Our ref: MC17/4125

Thank you for your letter of 6 September 2017, to the then Minister for Planning, the Honourable Jackie Trad MP, requesting approval to adopt the proposed Ferny Grove Upper-Kedron Neighbourhood Plan (the proposed amendment). I also note a subsequent letter on 14 September 2017, from Ms Andrea Kenafake, Acting Chief Executive Officer of the Brisbane City Council (the council), proposing the *Planning Act 2016* (the Planning Act) aligned version of the proposed amendment for adoption. As the Minister for State Development, Manufacturing, Infrastructure and Planning, I am now responding.

MINISTERIAL CONDITIONS FOR BRISBANE CITY COUNCIL'S PROPOSED FERNY GROVE UPPER KEDRON NEIGHBOURHOOD PLAN PURSUANT TO SECTION 117 OF THE SUSTAINABLE PLANNING ACT 2009

Map F version 3
Bushfire Prone Area
Ellendale - Upper Kedron
Including revised rehabilitation corridors

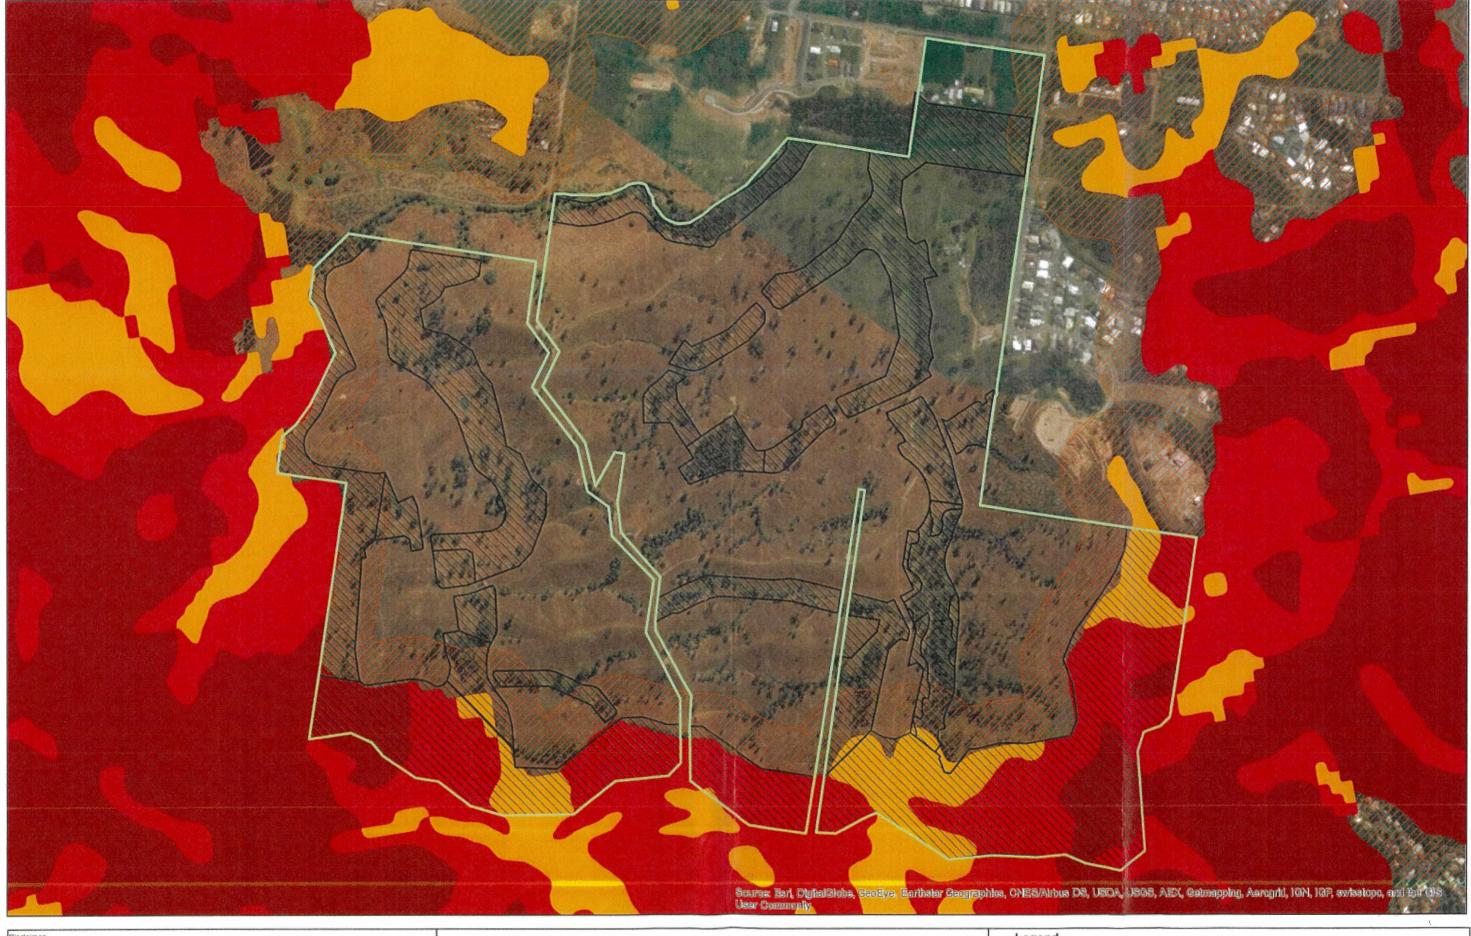
- (i) Include the enclosed regional ecosystems (REs)—Regional ecosystem vegetation communities planned for the Cedar Creek south-precinct to reflect the REs as shown on the attached "Cedar Woods Regional Ecosystem" (refer Enclosure 2) and amend Table 8.2.5.3.A, A021.2 (a) of the Performance outcomes and acceptable solutions of the Bushfire Overlay code to include the reference Regional ecosystem vegetation communities (as per Enclosure 2).
- (ii) Amend *Map 5—OM-002.3* to show the future bushfire risk for the Ferny Grove-Upper Kedron Area (as per **Enclosure 3**).
